Product change notification (PCN)

Title / short description	Adjustment of the inspection hole of the CK 4,0 contacts
Affected article category	Connector
Change category	Form and appearance
Change number	CBF230039-00
Reason for PCN/PDN Revision

CBF230039

Design changes

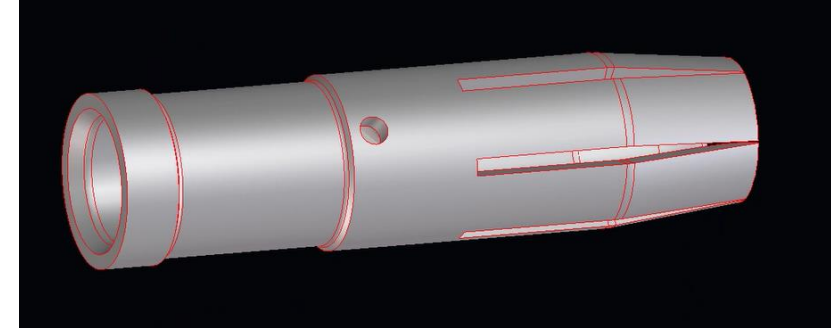
- On the contacts, the flush- or inspection hole is moved out of the crimping area by approx. 2mm in the direction of the contact pin/socket. The change means that the contact are better prepared for processing in automatic crimping machines. With the previous position of the hole, there is a risk of micro cracks forming when crimping with automatic crimping machines.
